Access Compliance Report

Public Rights-of-Way

(Curb Ramps)

Intersection ID: N/A	Main Street: YORK_CENTER	Cross Street: N/A	Location: NE
ADA ID: D70EB0824593	Ramp Type: PerpDiag	Initial Pass/Fail: Fail	Overall Compliance: No
Severity Score: 13.75			
Codes/Mitigation Info/Possible Solution		Field Measurements/Component Compliance

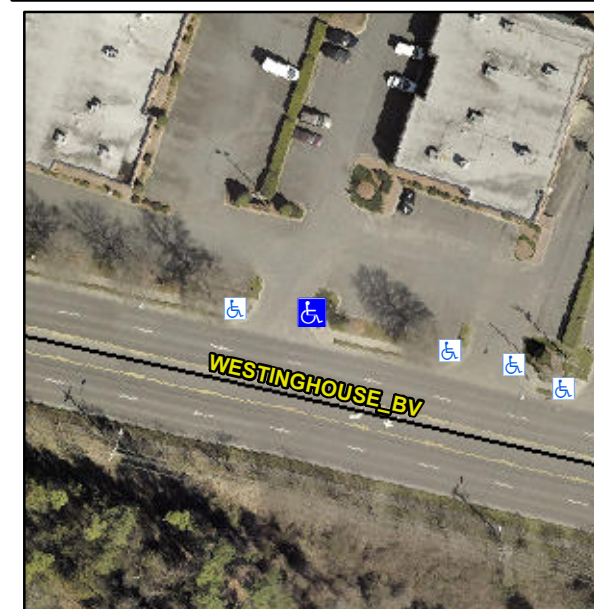
Not Found, R304.2.2, R304.5.3

Compliance	Description	Data	Compliance	Description	Data
N/A	Ramp Length (in)	83.0	No	Ramp Slope (%)	11.1
Yes	Ramp Width (in)	48.0	No	Ramp XSlope (%)	4.8
N/A	Flare Type LT	N/A	N/A	Flare Type RT	N/A
N/A	Flare Slope LT (%)	N/A	N/A	Flare Slope RT (%)	N/A
N/A	Flare Traversable LT?	N/A	N/A	Flare Traversable RT?	N/A
N/A	Landing Length (in)	N/A	N/A	DWS Provided?	N/A
N/A	Landing Width (in)	N/A	N/A	DWS Contrast?	N/A
N/A	Landing Slope (%)	N/A	N/A	DWS Length (in)	N/A
N/A	Landing X Slope (%)	N/A	N/A	DWS Full Width?	N/A
N/A	Landing Curb? (Y/N)	N/A	N/A	DWS Offset (in)	N/A
N/A	Shared Landing?	N/A			
N/A	Gutter Ponding?	N/A	N/A	Gutter Slope (%)	N/A
N/A	Gutter Lip Ht (in)	N/A	N/A	Gutter X Slope (%)	N/A
N/A	Painted X Walk1?	No	N/A	Painted X Walk2?	No
	X Walk 1 Direction	To W		X Walk 2 Direction	To S
N/A	X Walk 1 Width (in)	N/A	N/A	X Walk 2 Width (in)	N/A
	X Walk 1 Slope (%)	0.5		X Walk 2 Slope (%)	2.0
	X Walk 1 X Slope (%)	4.3		X Walk 2 X Slope (%)	1.8

Remove & Replace Curb Ramp With Two New Directional Ramps or Equivalent.
